**CITY OF TEMPE
REQUEST FOR COUNCIL ACTION**

**Council Meeting Date: 01/28/2016
Agenda Item: 6B2**

ACTION: Introduce and hold the first public hearing to adopt a Resolution for a General Plan Map Amendment, adopt an Ordinance for a Zoning Map Amendment from CSS to MU-4, a Planned Area Development Overlay and a Development Plan Review for a five-story building with 45 units and 5 live-work units for THE VALOR ON EIGHTH, located at 1001 East Eighth Street. The applicant is Manjula Vaz, Gammage & Burnham PLC. (Note, the General Plan Amendment requires an affirmative vote of at least two-thirds (2/3) of the City Council; therefore a Council vote of 5 of 7 is required for approval.) The second and final public hearing is scheduled for February 11, 2016. (Resolution No. R2016.13) (Ordinance No. O2016.10)

Site Plan

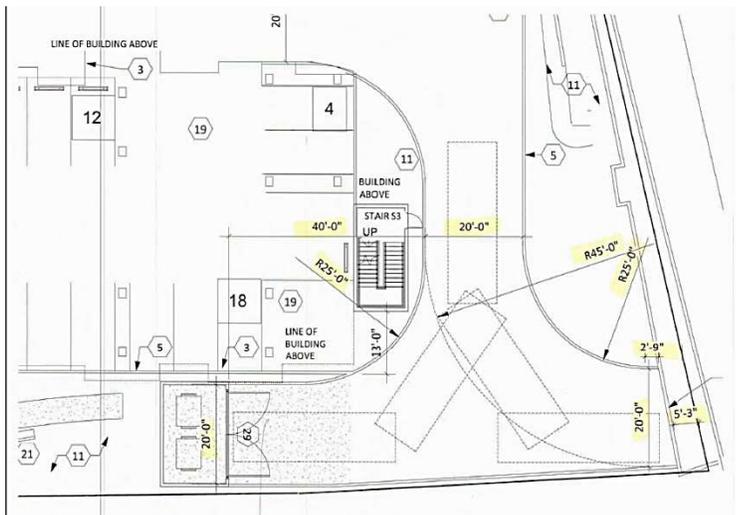
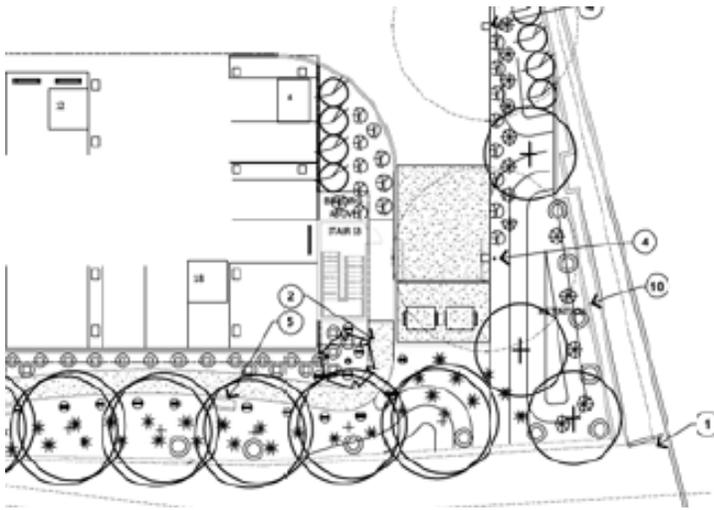
The building is oriented on the eastern side of the site, with a north/south orientation. The structure has a centralized light court between a building that is U shaped in design with a central light court allowing morning and midday light into the units, but shading the structure from afternoon glare. The first floor is a storefront screening podium parking that is open on the south side. The site is accessed by vehicles on the east side, within the 38-foot side yard setback. Refuse is tucked back at the south east corner. A revised site plan was presented to Solid Waste Services staff to address circulation concerns. Below is the original proposed refuse layout as shown on the landscape plan, and the new revised solution that meets refuse collection requirements. Approximately five trees will be affected by the solution however these are not required trees. This solution keeps the refuse away from the condominiums to the east, hides the enclosure from street view, and provides a turn-around for refuse trucks without requiring a backup into the parking drive entry.

The west side of the property has a private playground and ramada for resident use, and a public multi-modal path outside of the fenced landscape amenity area. A retention area is located west of the path, and is lit and landscaped for public safety. The site has a large percentage of open space, providing a break in the wall of development further east. The street front has two sidewalks, the existing 6' sidewalk, a 12' deep landscape island extends the length of the building broken by 6' connecting paths leading to a second 6' wide integrally colored paver path connecting the live-work units, leasing office, and community room.
